UNITED STATES ENVIRONMENTAL PROTECTION AGENCY
WASHINGTON, D.C. 20460

ENVIRONMENTAL IMPACT STATEMENT COMMENTS

Dresden Nuclear Power Station

The Environmental Protection Agency has reviewed the draft environmental impact statement (EIS) for the Dresden Nuclear Power Station, Units 2 & 3 prepared by the U.S. Atomic Energy Commission and issued on June 26, 1973. The following are our major conclusions:

FIGURE 1

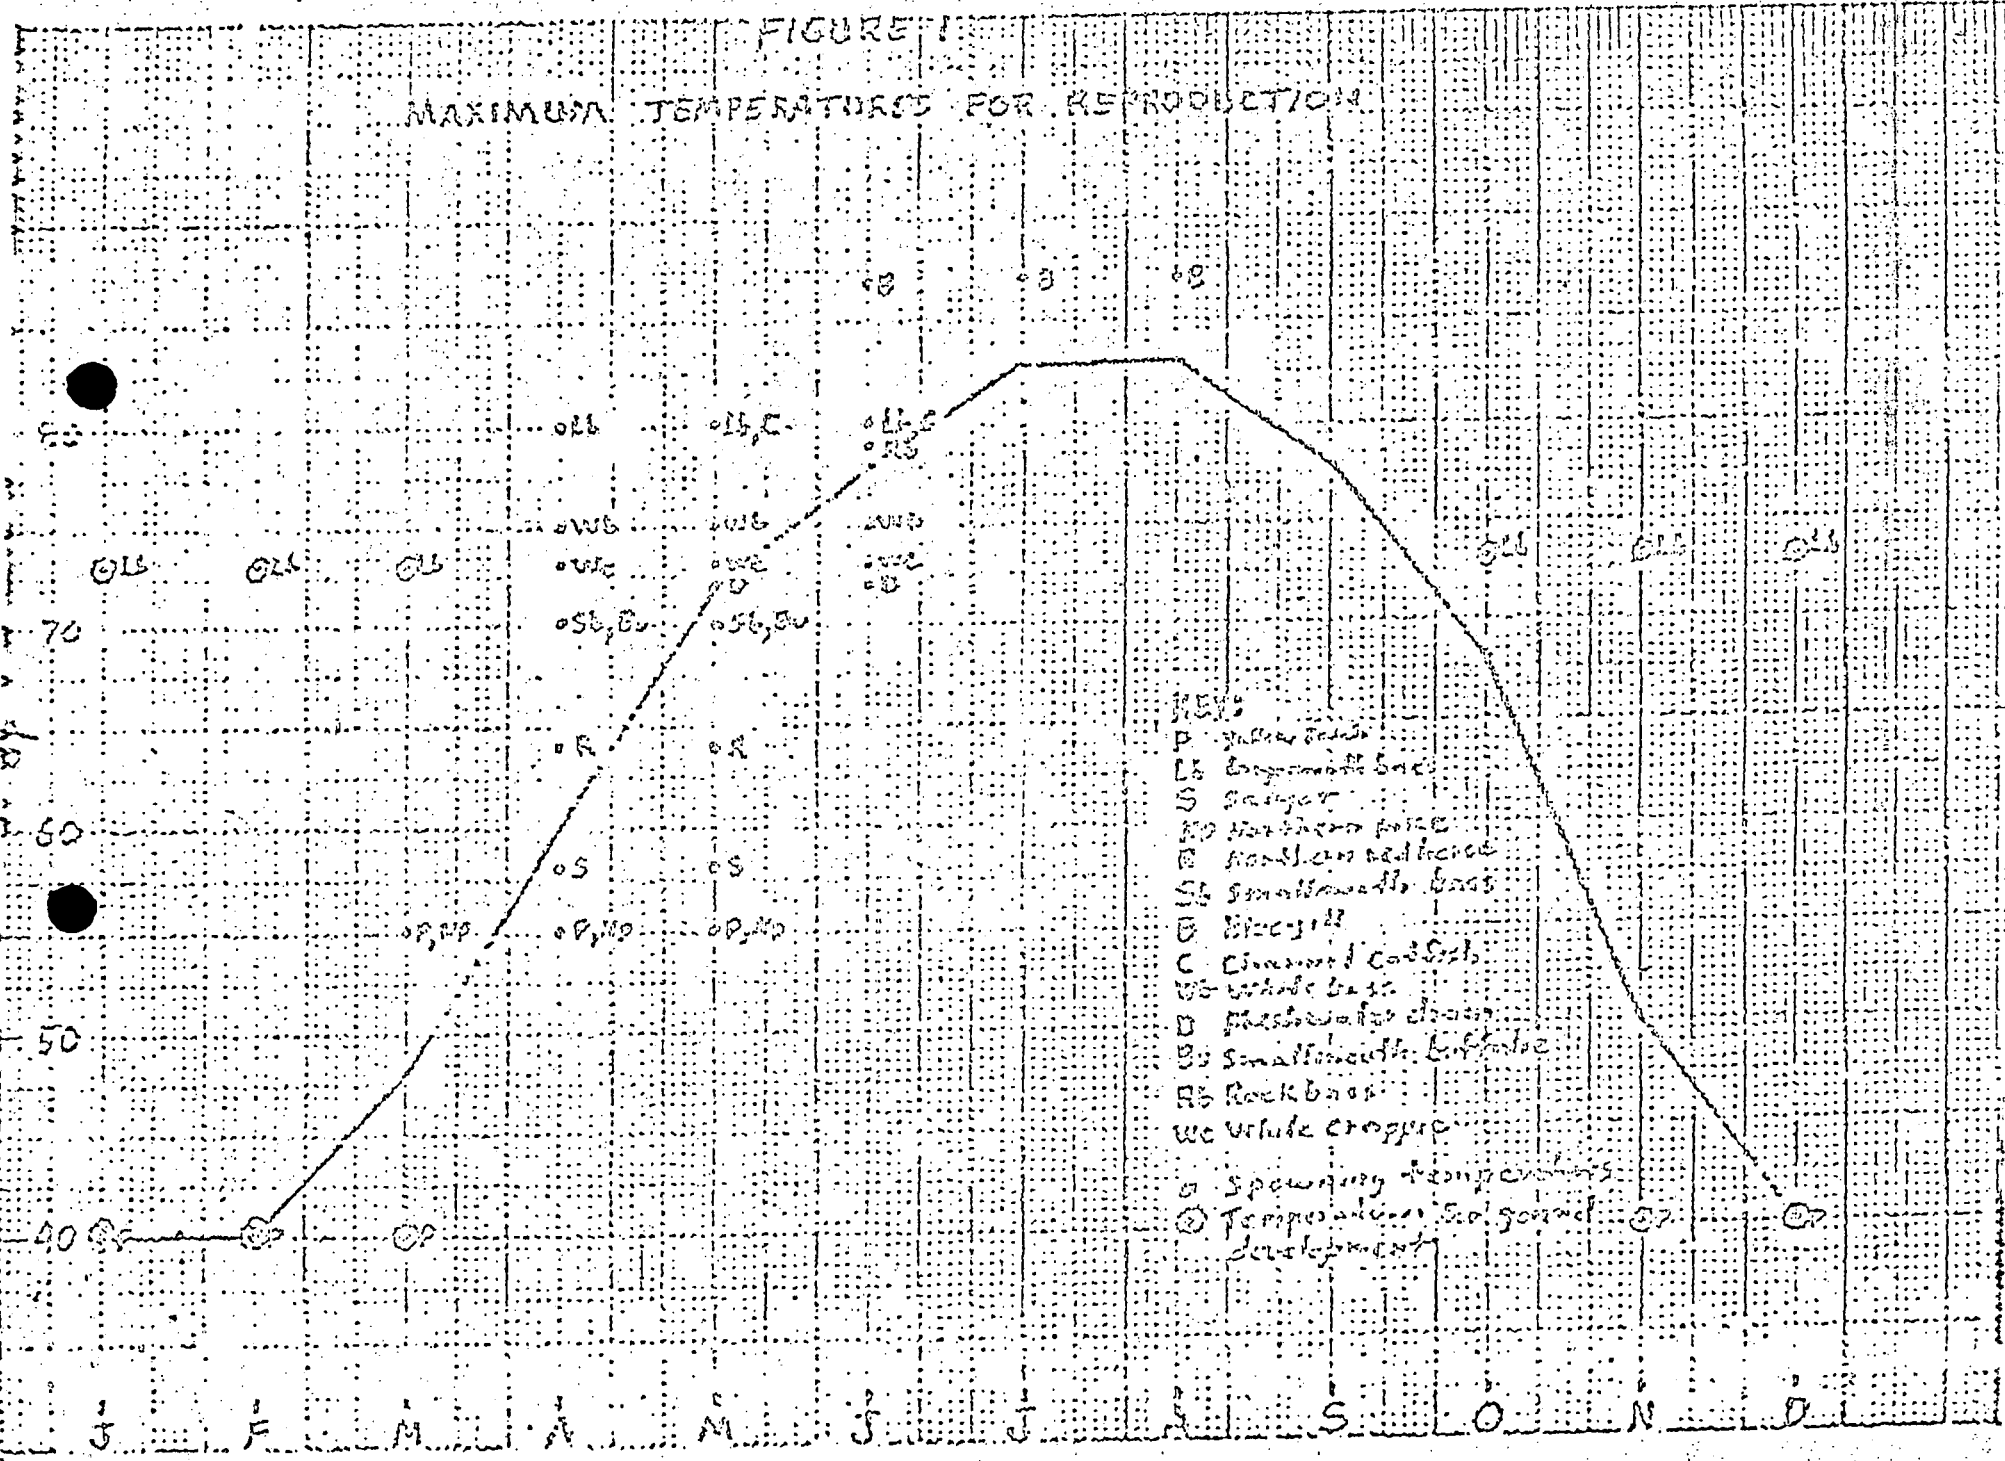
development and spawning in Table 2 are plotted in Figure 1 with a superimposed curve showing the recommended criteria in relation to requirements for reproduction of the various species. Incubation data are not plotted in Figure 1 since temperatures near the maximum for spawning, for most species, will be within the range of tolerance of the embryo. Data are not available for all species. However, it seems reasonable to expect conditions suitable for yellow perch which require prolonged exposure to low temperature in winter for development of gonads and successful spawning to be suitable for walleye and sauger. Extrapolation among species is also necessary to some extent among the bass-panfish, catfish and rock-bass groups.

Should a less restrictive criteria providing a lesser degree of protection to fish populations be desired for certain stretches of the Illinois River, the curve for such criteria could also be plotted on Figure 1 to reveal the probable adverse effect on fish populations.
